P 35786  
A REPAIR

SEWAGE DISPOSAL SYSTEM

HOWARD COUNTY  
BUREAU OF ENVIRONMENTAL HEALTH  
992-2330

SUBDIVISION \_\_\_\_\_ ROAD 3101 Cabin Run LOT \_\_\_\_\_

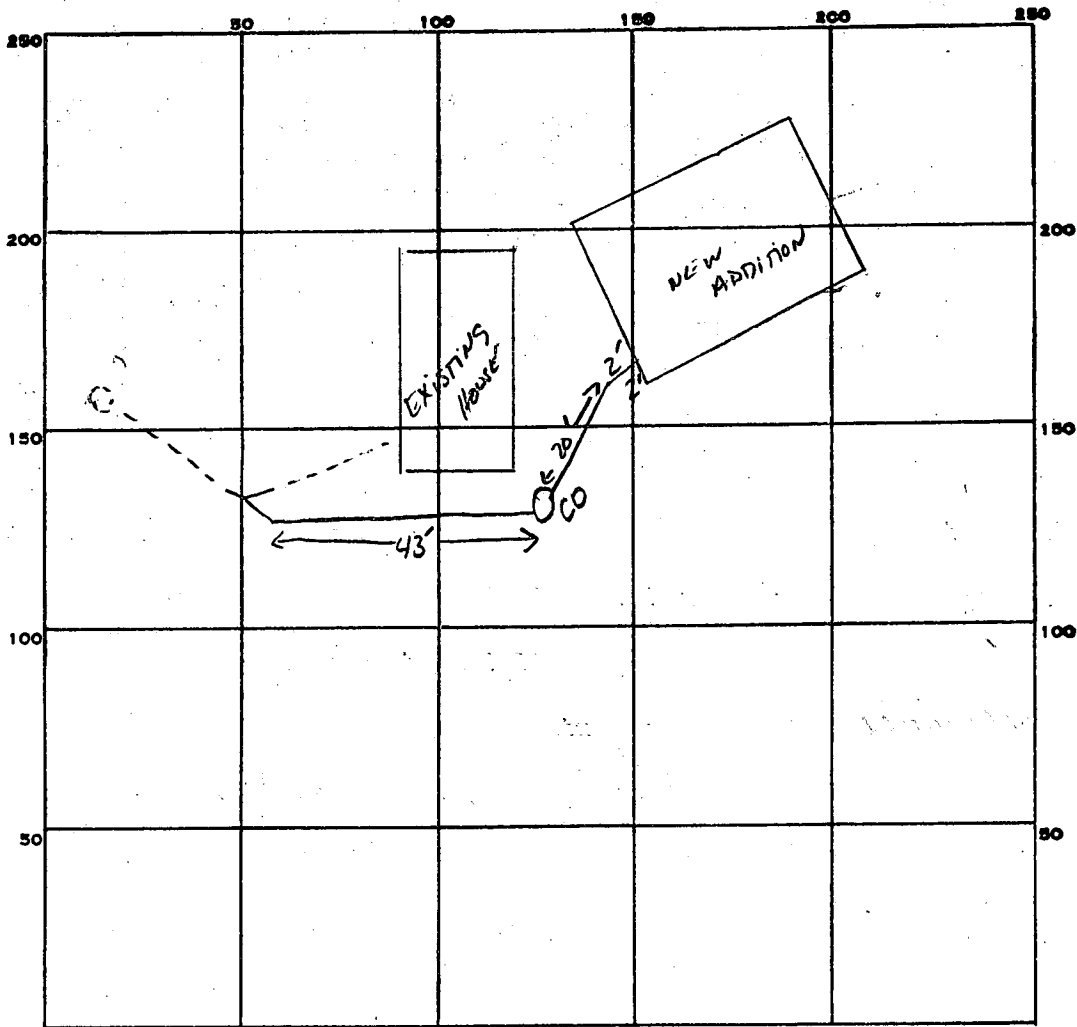
New sewer pipe added between recent new addition & existing septic tank F.S.

*NEW PIPE*  
 DATE SYSTEM APPROVED \_\_\_\_\_

3101 Cabin Run

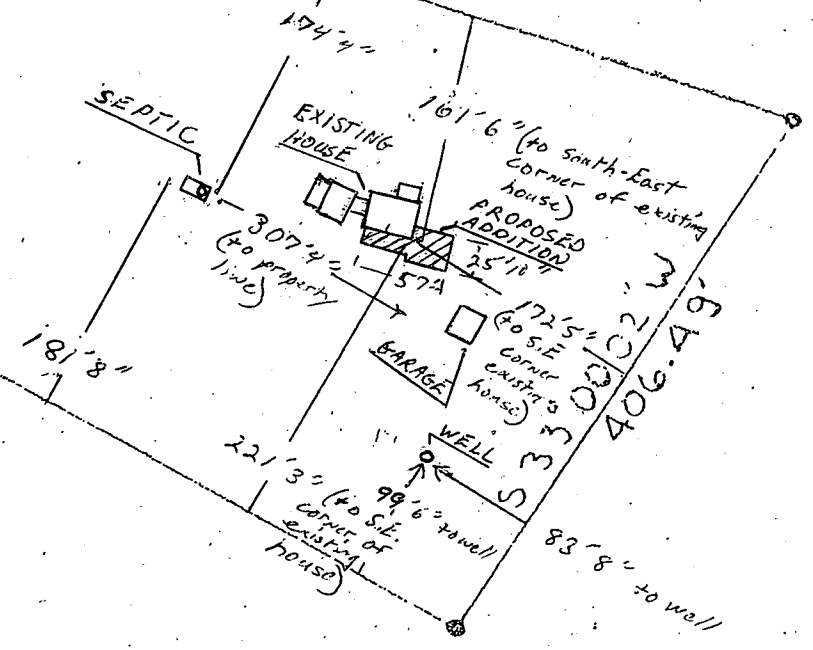
PROPOSED ADDITION  
OK. No ↑ in bd rms  
& NO SETBACK ISSUES.
